FOIA/PA NO: 2015-0176

From: Tammara, Seshagiri
Sent: Tuesday, August 26, 2014 8:10 AM
To: McCoppin, Michael
Subject: FW: Indian Point Gas Pipeline 50.59 Evaluation Part 1 of 3

From: Pickett, Douglas
Sent: Monday, August 25, 2014 4:04 PM
To: Tammara, Seshagiri; McCoppin, Michael
Cc: Tift, Doug; Burritt, Arthur; McNamara, Nancy; Screnci, Diane; Sheehan, Neil; Beasley, Benjamin
Subject: Indian Point Gas Pipeline 50.59 Evaluation Part 1 of 3

Spectra Energy has proposed building a 42-inch natural gas pipeline that will traverse a portion of the Indian Point owner controlled property. Entergy, the licensee, performed a site hazards analysis and concluded that the new pipeline will not introduce any increased risks. The licensee has submitted their 50.59 evaluation on the docket and Region 1 plans to review the evaluation but will need technical assistance with regard to performing an independent verification of the licensee's blast analysis. Could you please take an initial look at the licensee's evaluation and let me know whether you will have all the information you will need to perform a confirmatory analysis? Once Region 1 and NRR confer, I will let you know what kind of schedule

Simplified Schematic - Algonquin Gas Transmission Pipelines Stony Pt to Southeast Compressor Stations Looped Segment Pre & Post AIM Project Proposal

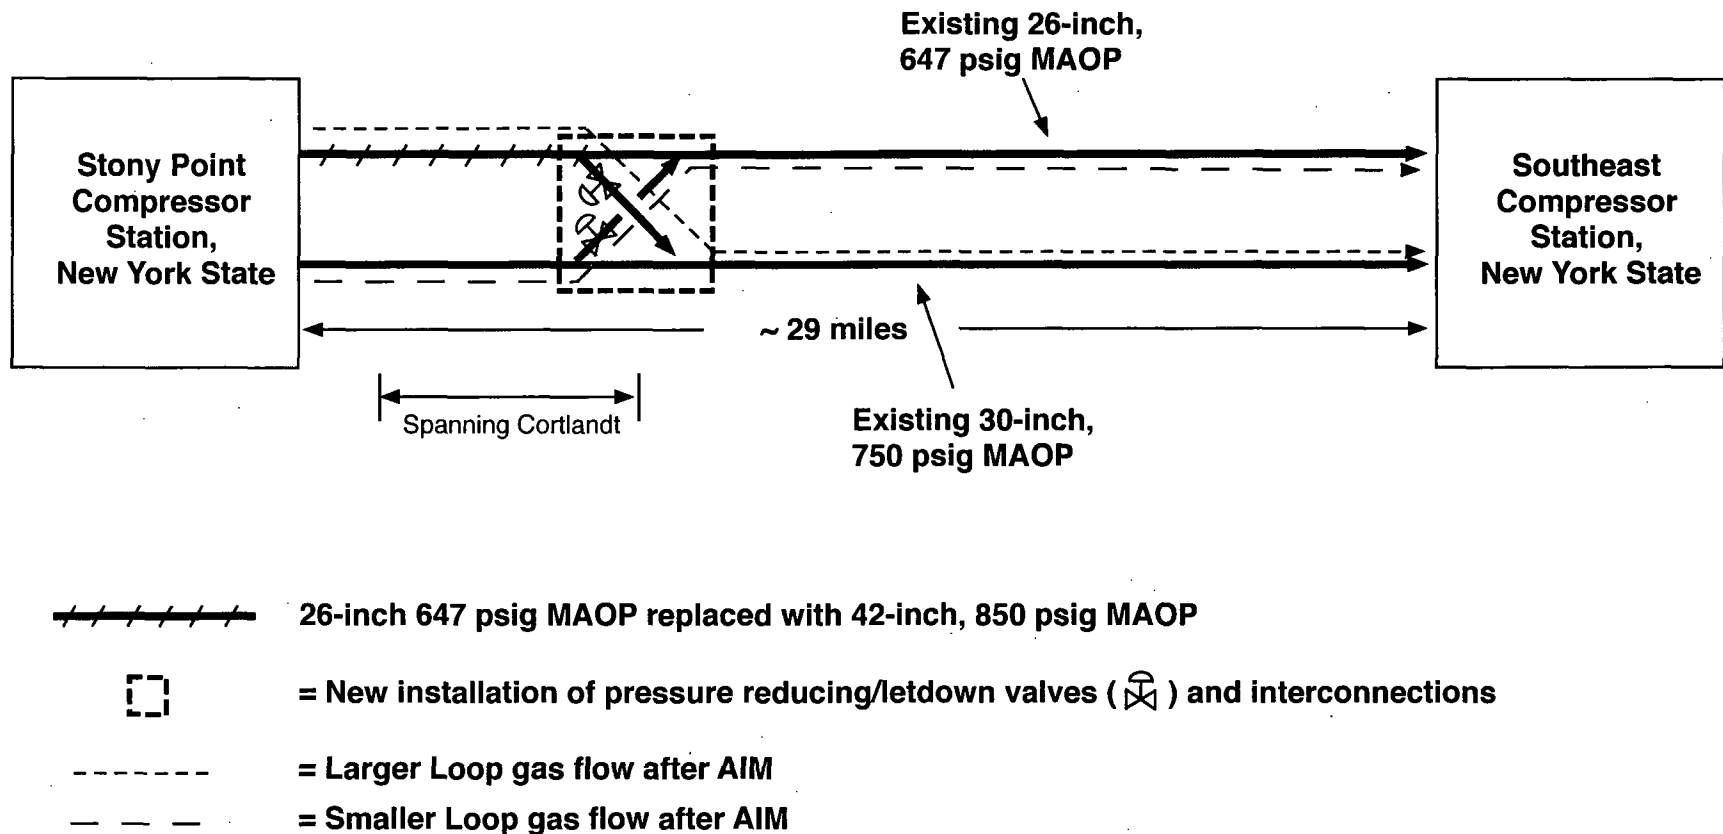
Cortlandt. The AIM Project is proposing to modify the pipeline segments between the Stony Point and Southeast Compressor Stations into two significantly different operating loops via new mainline interconnects utilizing pressure reducing/letdown valving installations, and various pig launcher/receiver modifications (to be installed within Cortlandt) to produce: (a) a “Smaller Loop” mainline system consisting of first an existing 30-inch pipeline reducing to an already existing 26-inch mainline, and (b) a “Larger Loop” mainline system consisting of new proposed 42-inch pipe reducing down to an already existing downstream 30-inch mainline (See Exhibit 1).⁵

Exhibit 2 – AIM Project Overview Map from DEIS Showing General Location of Replacement of 26-inch with 42-Inch Pipeline Across Cortland, NY

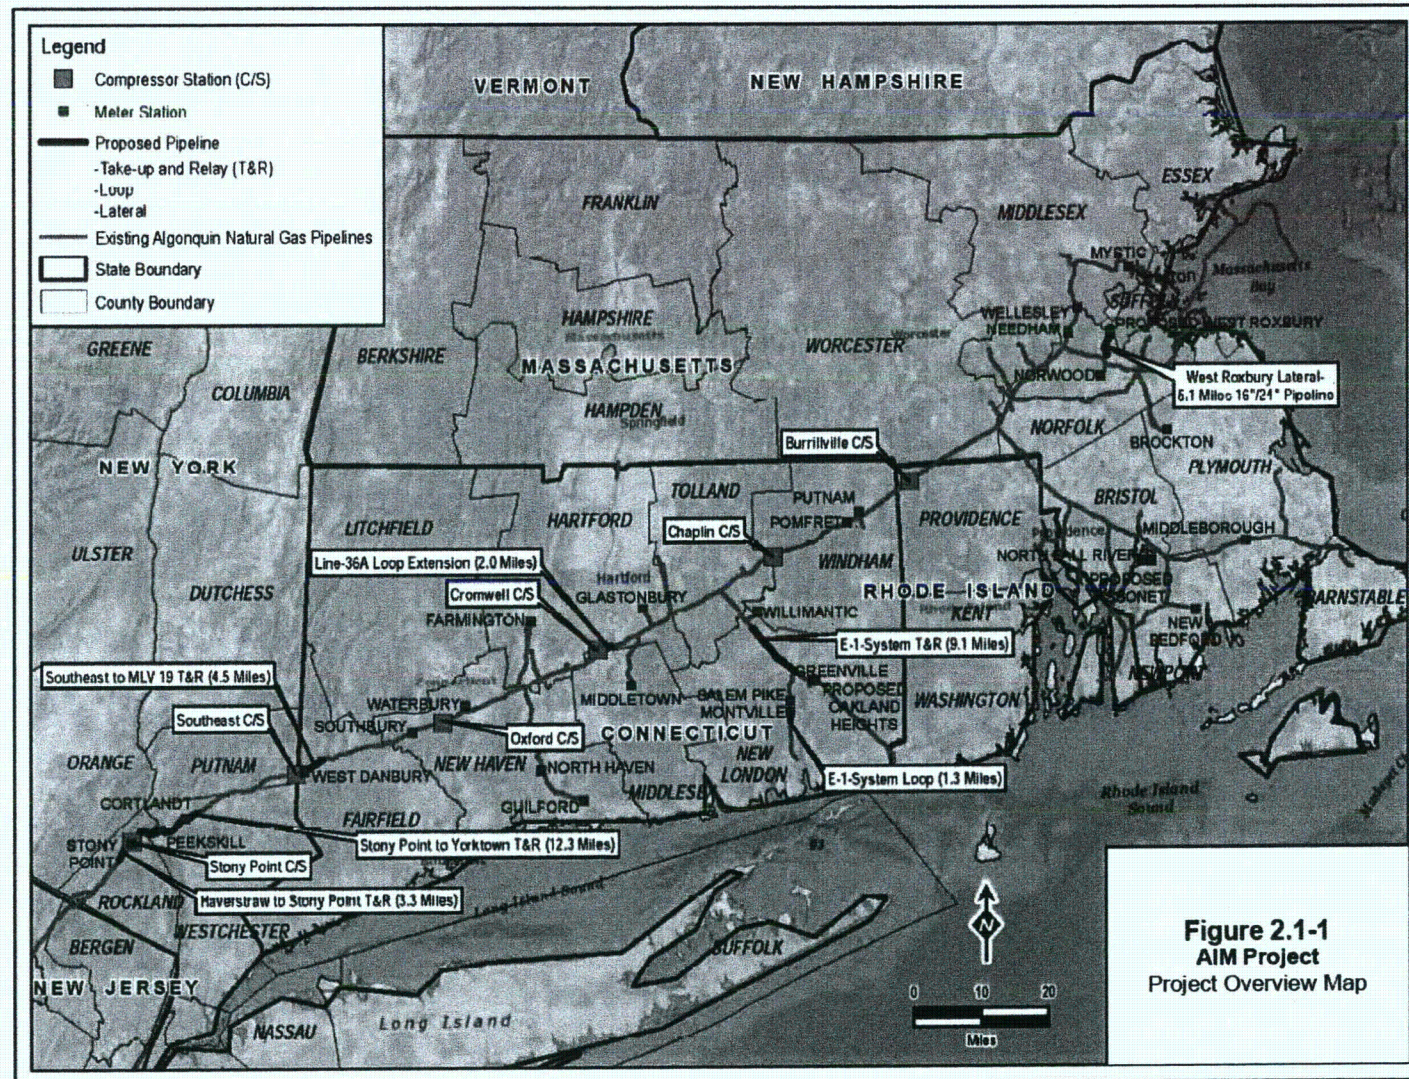
- 2) Exhibit 2 is a figure captured from the AIM Project DEIS showing the relative location of where the existing 26-inch pipeline will be removed and replaced by new 42-inch pipeline that AIM has labeled “Take-up and Relay (T&R),” in essentially the same right-of-way (“ROW”) through most of Cortlandt.⁶

Exhibit 3 – Algonquin Pipeline Hudson River Crossings, Existing and Proposed from AIM DEIS

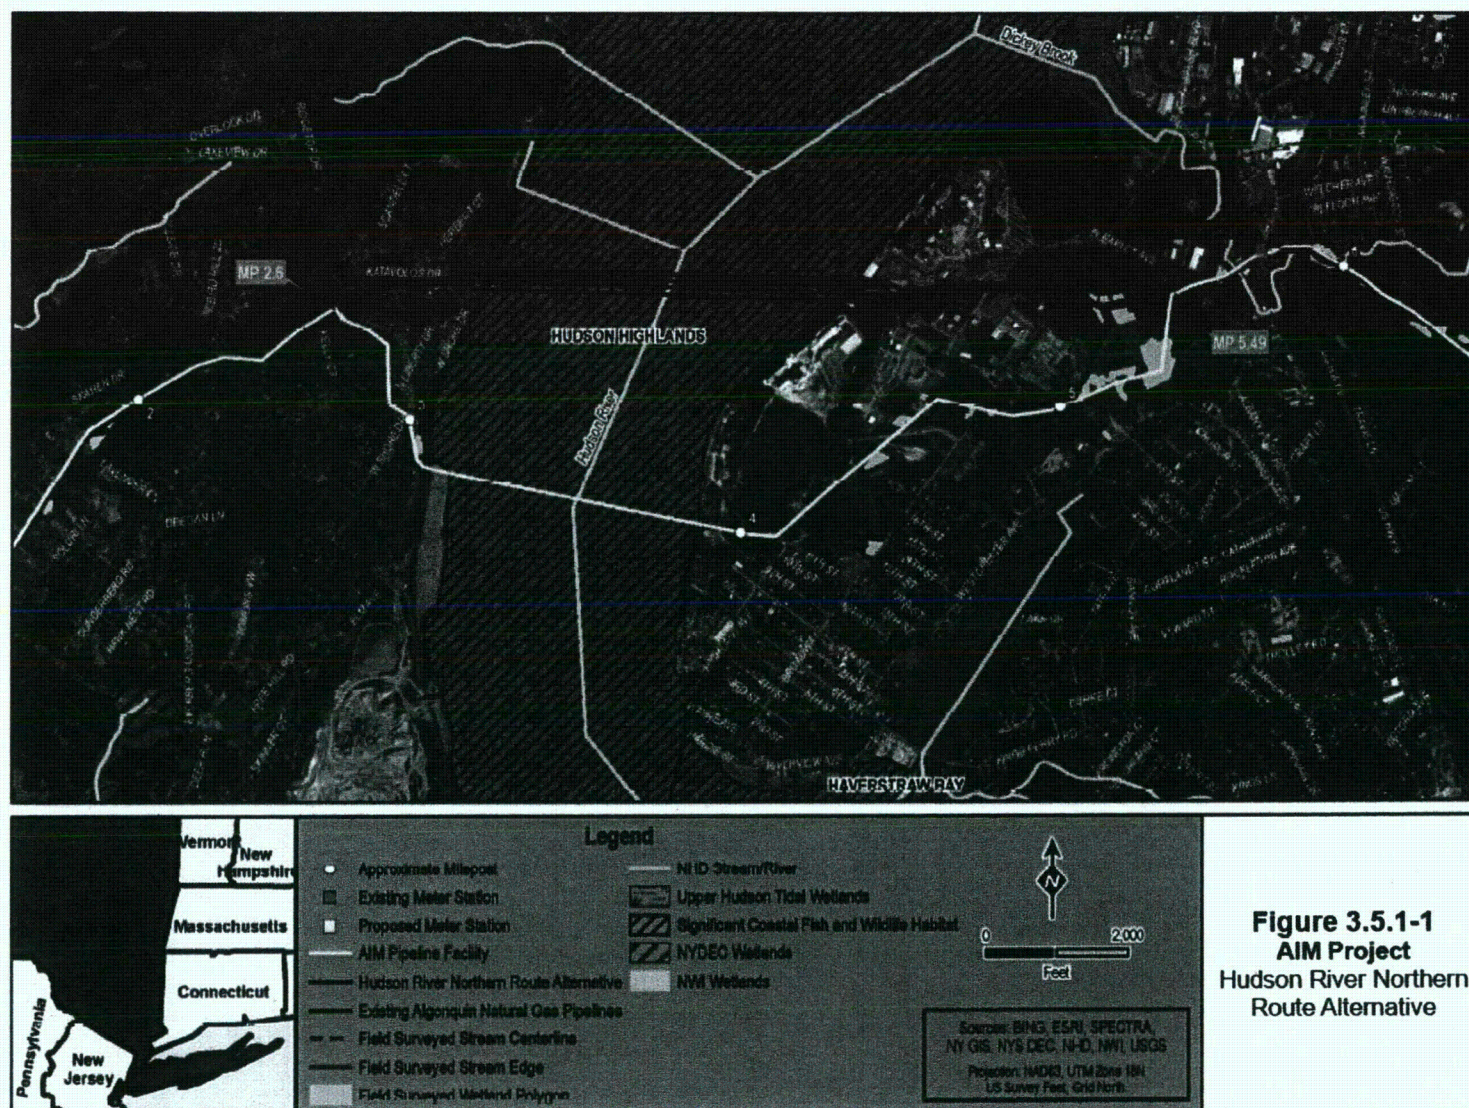
- 3) Exhibit 3 is a figure taken from the AIM DEIS depicting existing and proposed Algonquin Hudson River crossings for the AIM Project.⁷
- 4) Exhibit 4 (CEII Protected) is a hydraulic profile (pipeline pressure vs. pipeline milepost) developed by Accufacts for the smaller diameter (30-inch and 26-inch) lower MAOP pipeline (Smaller Loop) segment within New York State, pre and post AIM Project, for the pipelines between the Stony Point and Southeast compressor stations, incorporating Exhibit G information provided by Algonquin’s submission to FERC.
